BID: FR-24 ISLANDTON FIRE STATION 15 EXPANSION

ADDENDUM 1 DATED: MARCH 18, 2020

The following questions have been submitted for clarification:

CONSTRUCTION 01/10/2020 DOCUMENTS **BUILDING &** WALL **SECTIONS**

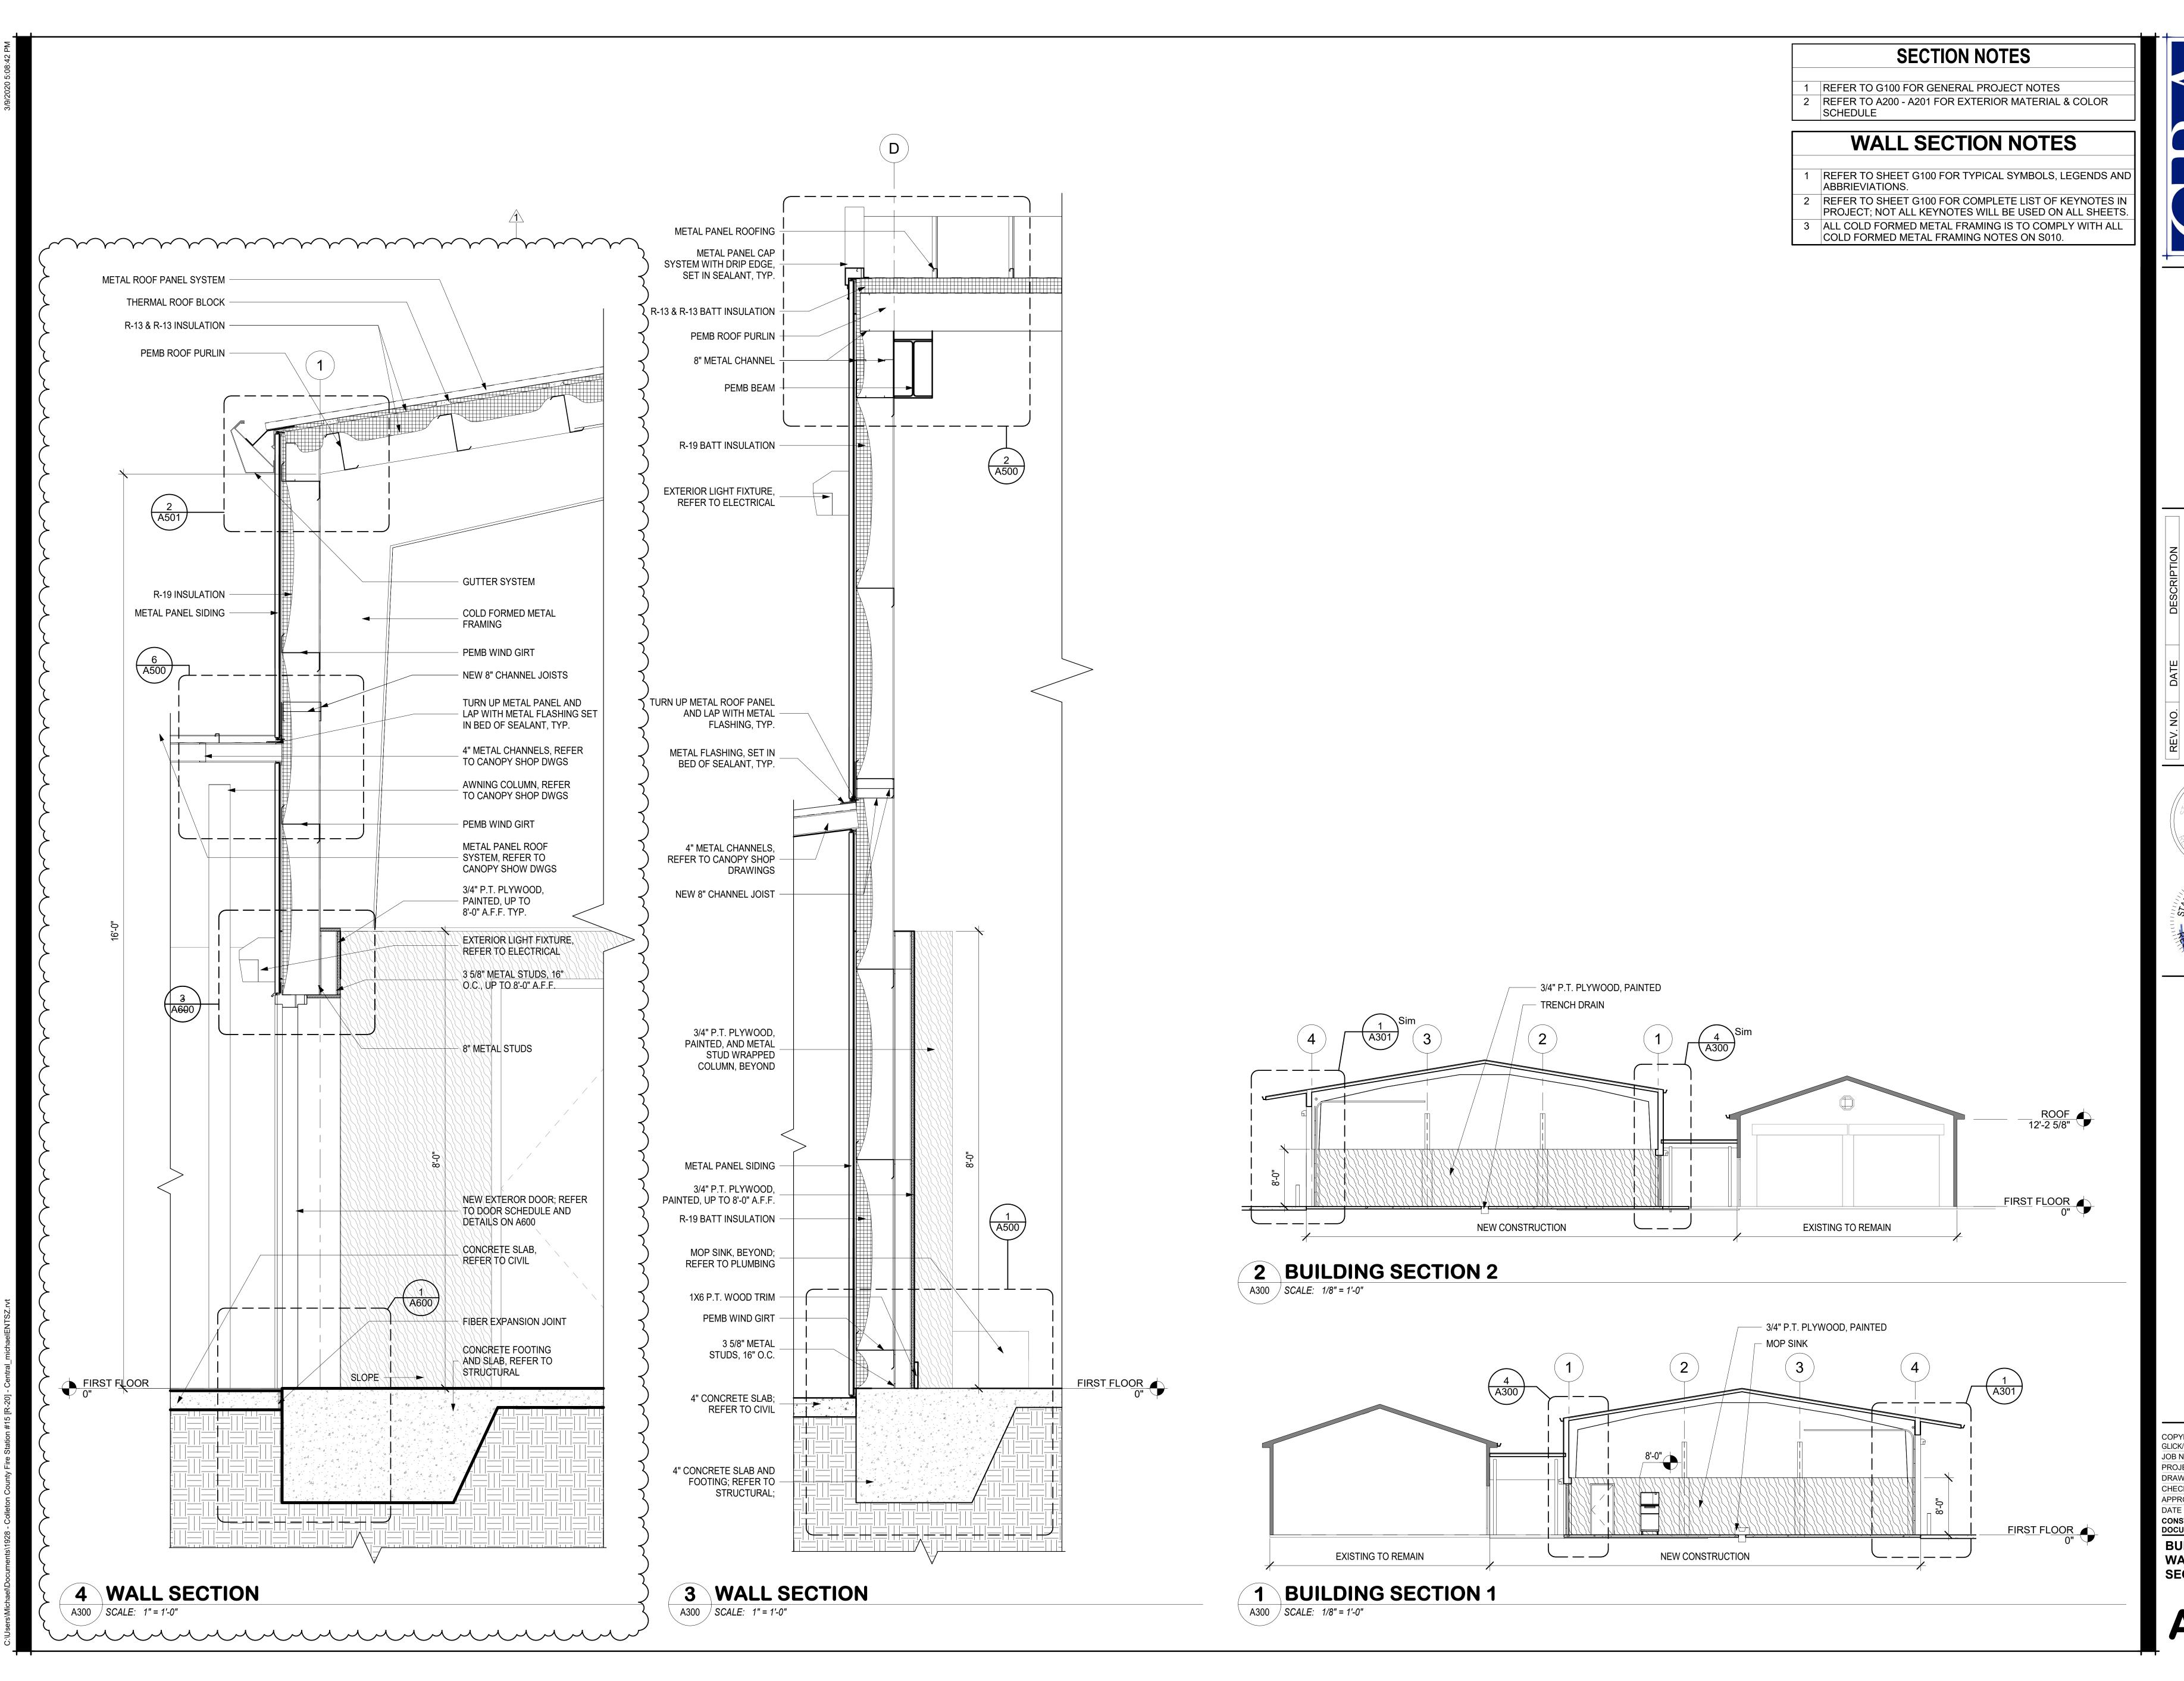
- 3. What is the eave height of the metal building? <u>Answer:</u> See attached revised A300 providing vertical dimension.
- 4. Please provide locations and/or quantities of fire extinguishers desired. Answer: Provide one (1) fire extinguisher and bracket. Location to be provided by the owner.

- 23. Will the Canopy need gutters and downs? Answer: Yes
- 24. What is the Height to the top of the gutter/eave strut? Answer: See revised sheet A300 for eave strut height for the main bldg. The lowest structural element for the canopies roof shall not be lower than 8"-2" above the building slab floor.

CONSTRUCTION 01/10/2020 **ELEVATIONS**

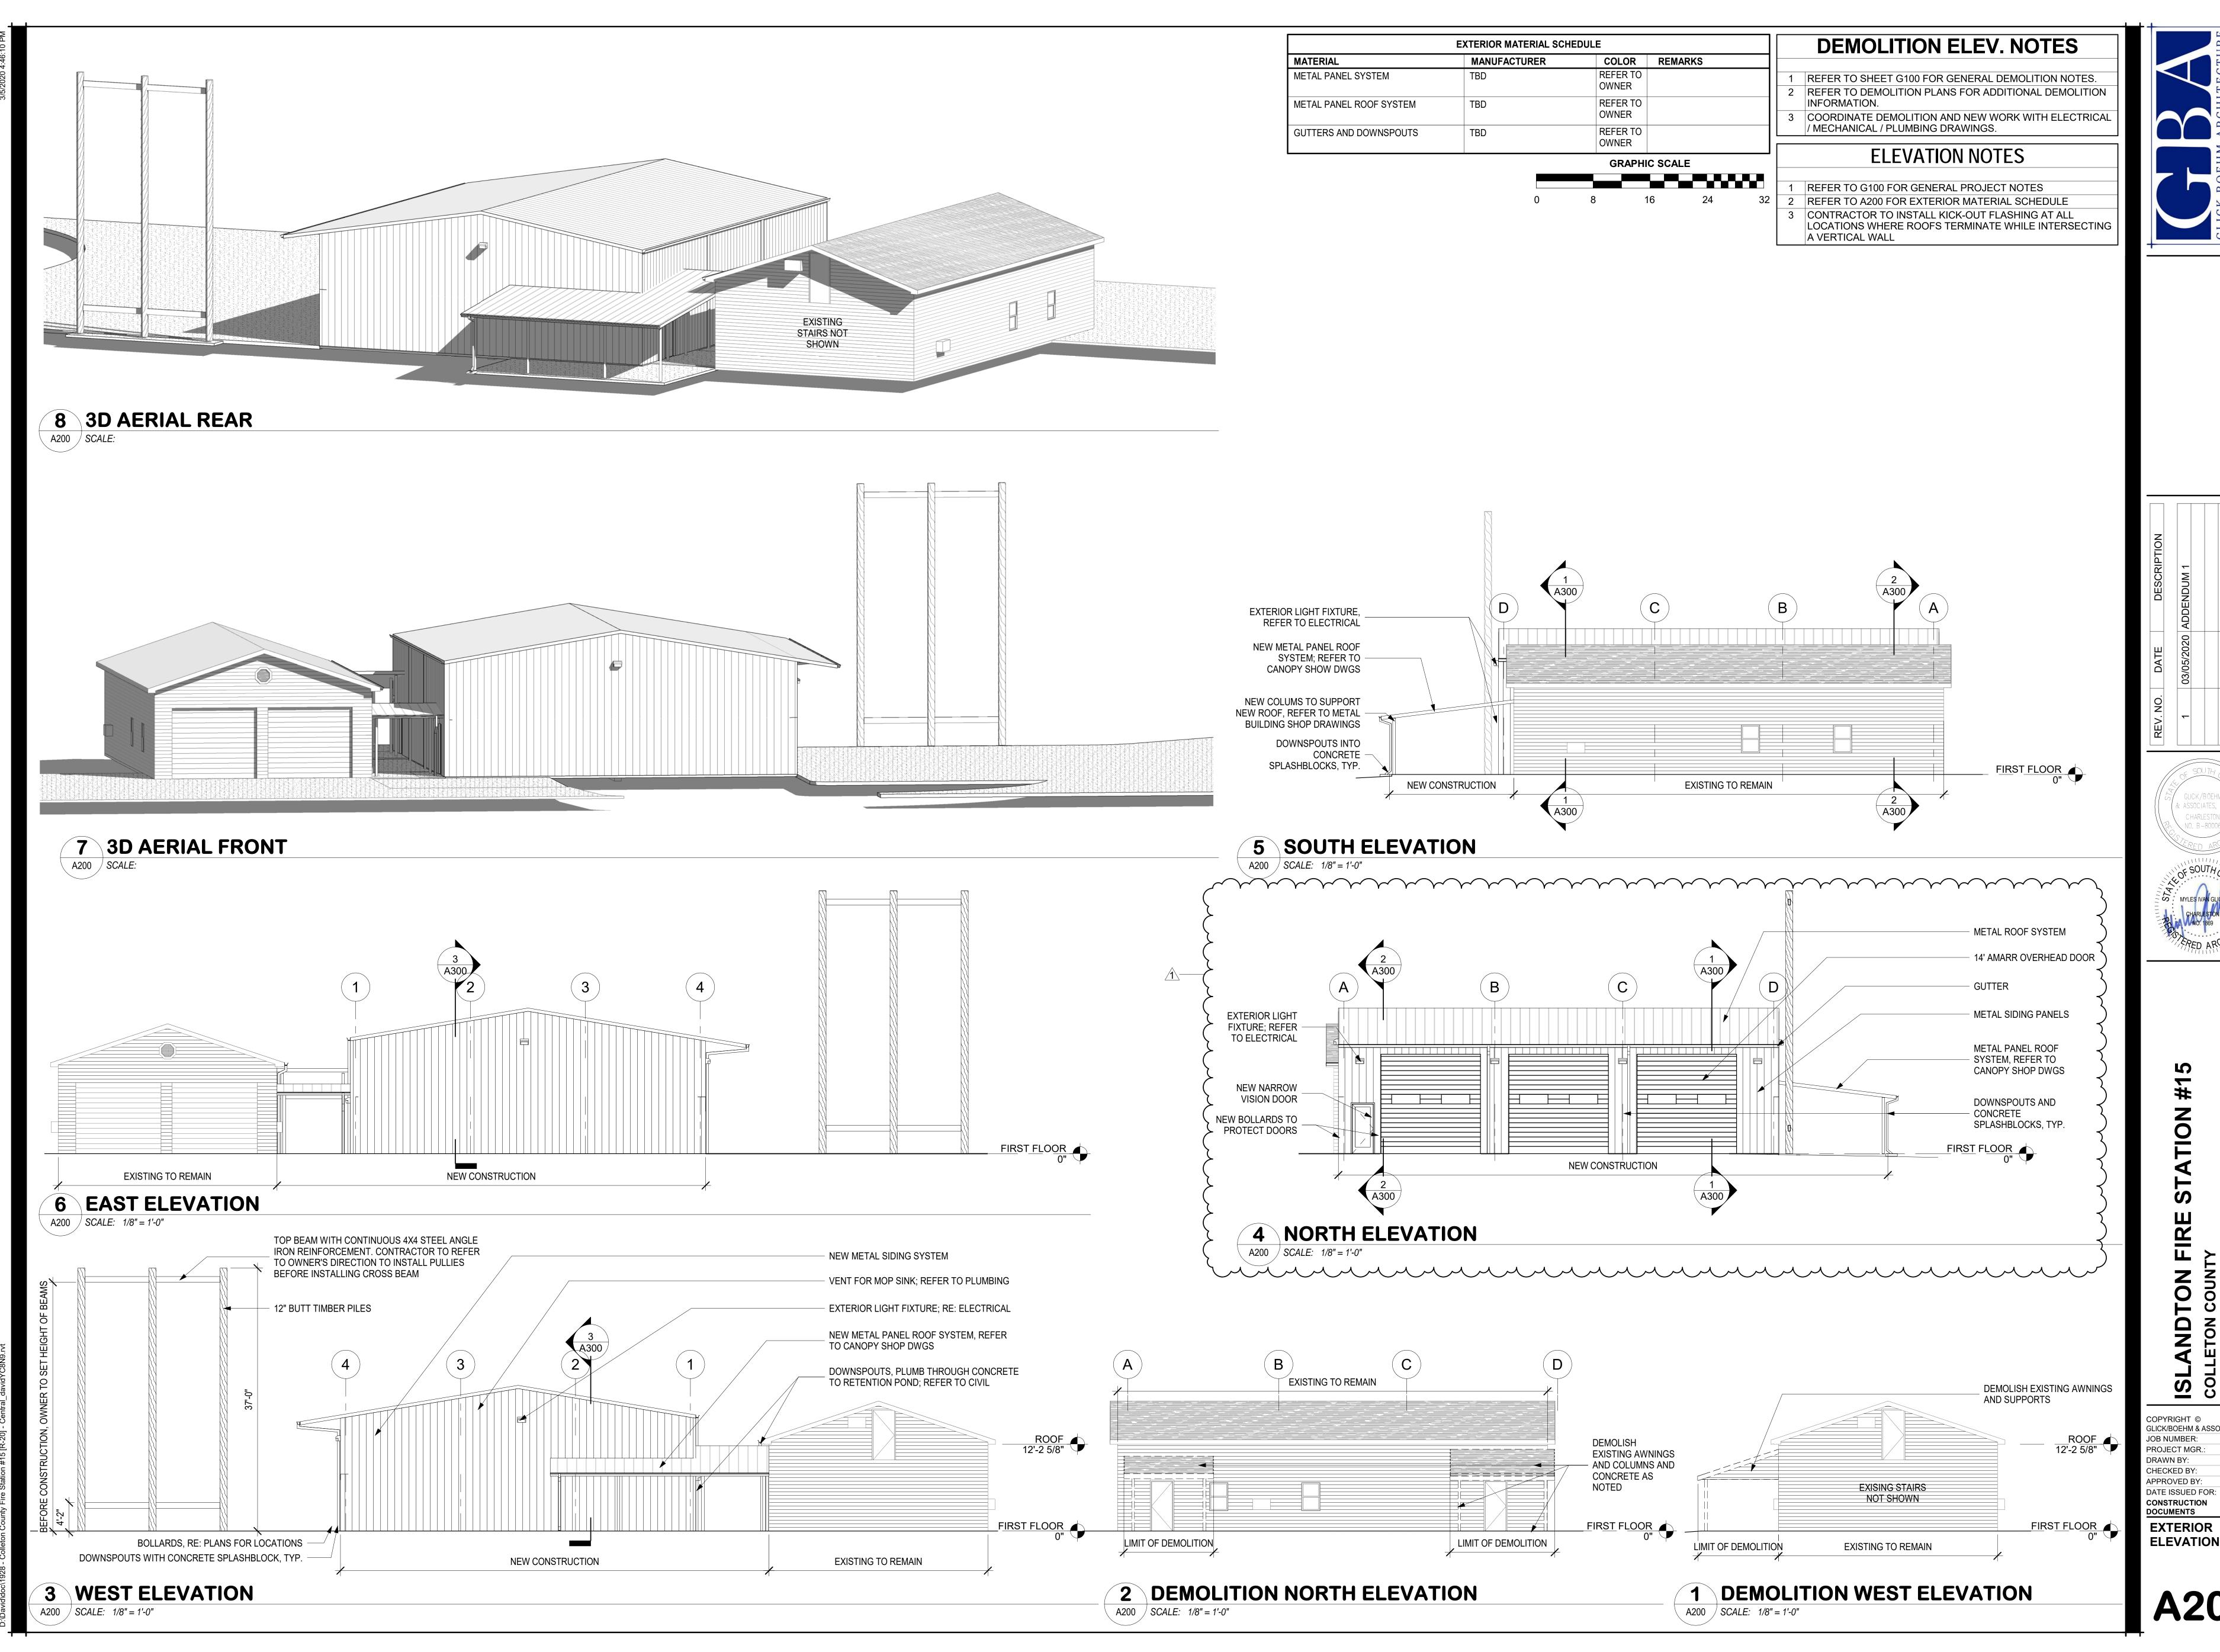
- 5. The door elevation of the OH Door shown on A600 indicates (3) lights, however, the building elevations on A200 do not. Which is correct? Answer: Provide windows in garage door per revised A200 & A600 attached. The garage door shall be Amarr-2432 2" Polystyrene Insulated Section Door. See attached door provider and installer.
